Development Permit Panel

MINUTES

1. DEVELOPMENT PERMIT 11-593871
(REDMS No. 6204334 v. 2)

PROPERTY LOCATION: 6302 No. 3 Road and 6411 Buswell Street

Acoustic Screen
Scale: 1/4" = 1'-0"

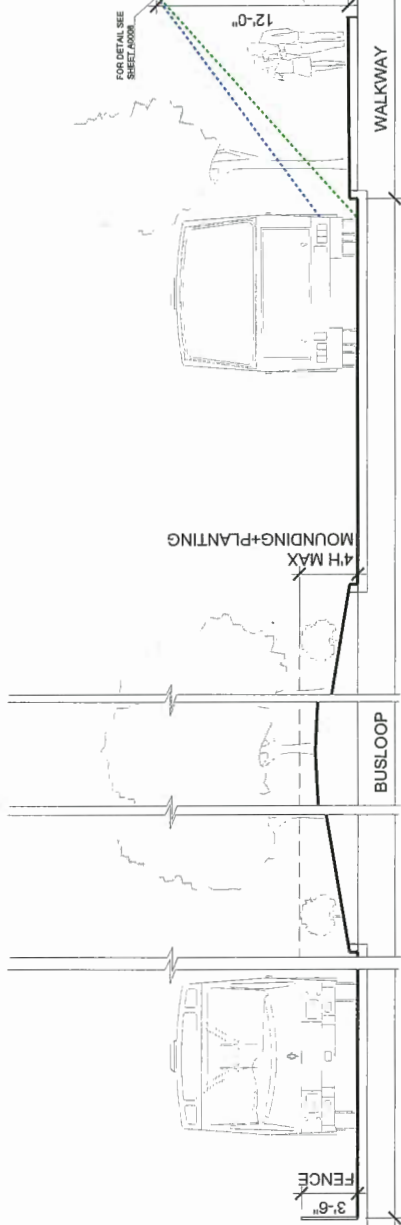
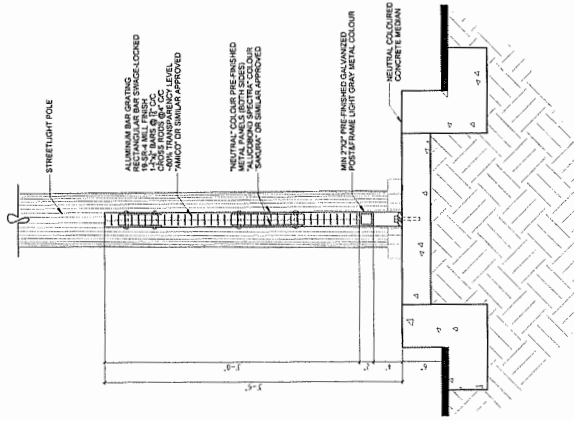
1) According to Key Plan on Document A0005, the proposed acoustic wall only covers the first three townhouse units from the left. Is this enough to protect the entire row of townhouses along the proposed bus mall?

3b) Is 12 feet tall wall enough to provide protection on the top floor patio (exterior of the 4th floor, as opposed to the interior portion)?

1. Townhouses at the east end will have a partial view to buses past the end of the barrier. Our evaluation indicates bus noise should be less than 60 dB at these townhouses, based on the reduced angle of view and increased distance from the source.
2. CMHC recommends 55 dB for outdoor recreation areas, which "permits conversation at close range or in a slightly raised voice" and is not a design requirement for patios, balconies, etc. For reference, traffic noise normally exceeds 55 dB on balconies in proximity to arterial roads.

On the Level 4 townhouse rooftop patios the estimated level is 55 dB, based on the outside design level of 65 dB from bus movements and a nominal 10 decibel reduction for an individual seated behind the glazed balustrade. No reduction from the proposed barrier has been considered.

3a.) The barrier will provide a nominal 5-10 decibel reduction at locations where the line of sight to buses is through the barrier. A 12ft high barrier would provide slightly more shielding than a 9ft barrier.

Section through bus loop - A

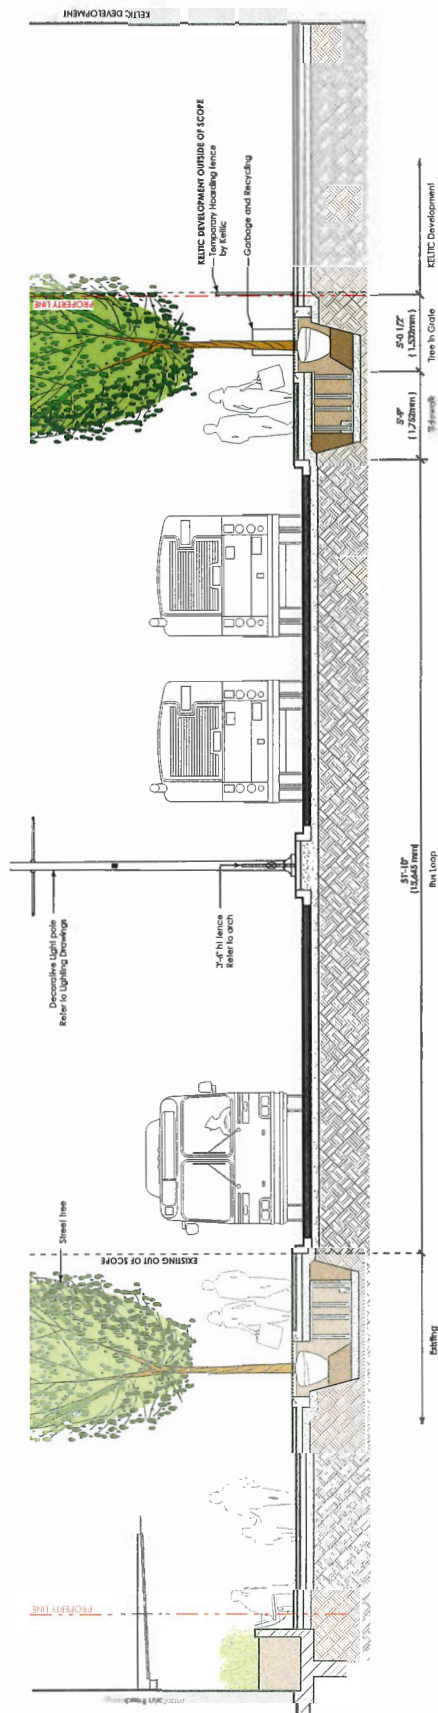
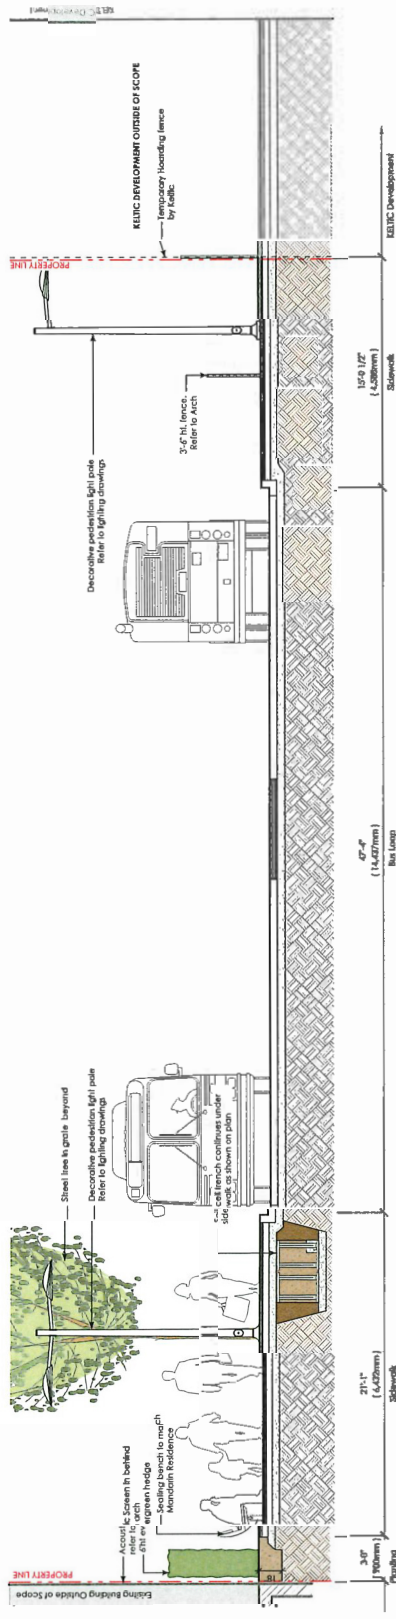
I also attach details of the acoustic wall itself. You will notice on the cross-section drawing, lines which emanate from the bottom of the wheels of the bus. The point of contact where the wheels meet the pavement is typically the primary source of noise. The height of the acoustic fence is such that it shields the lower 4 floors of Emporio from this direct noise.
